TRANS/WP.29/GRE/2002/45
23 July 2002

World Forum for Harmonization of Vehicle Regulations (WP.29)

PROPOSAL FOR DRAFT AMENDMENTS TO DRAFT REGULATION ON
ADAPTATIVE FRONT-LIGHTING SYSTEM (AFS)

Transmitted by the Expert from Poland

"Fig. 1. Points position on the road surface (RS).

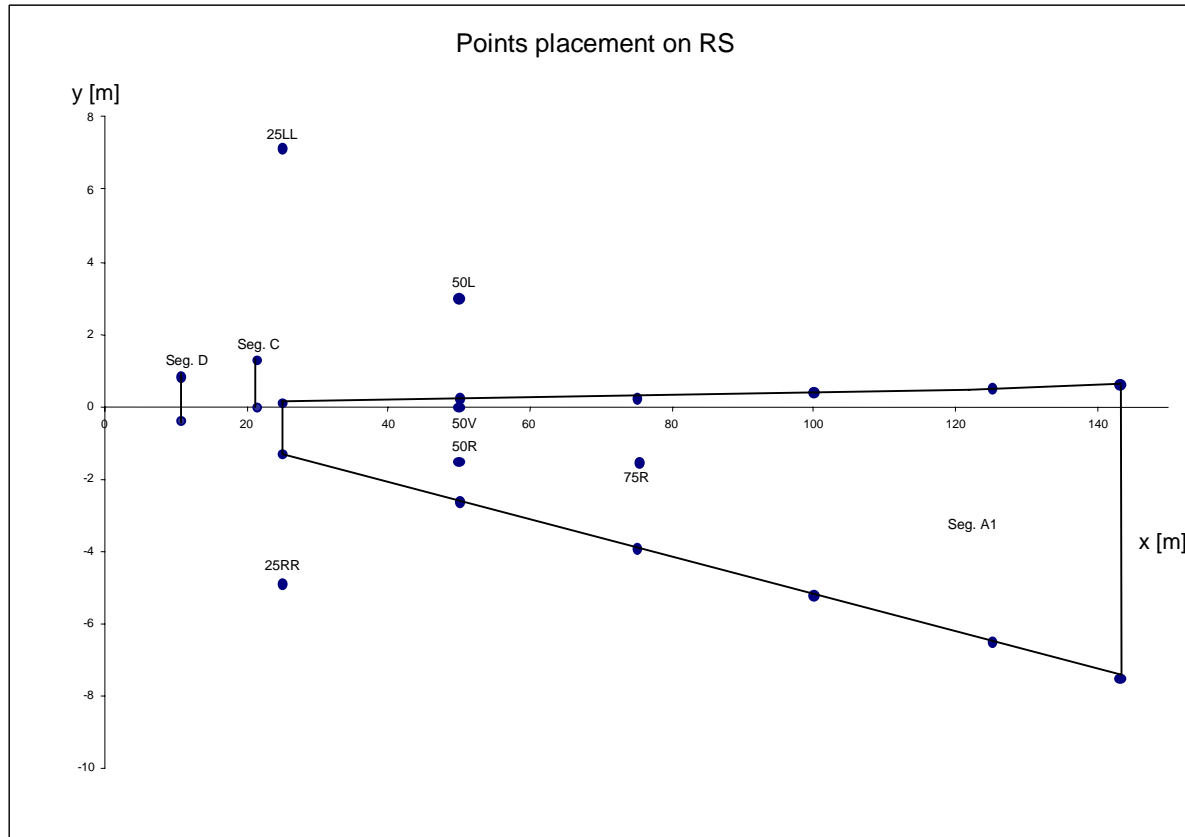
Insert new figures 1 and 2 and tables 1 to 2, to read:
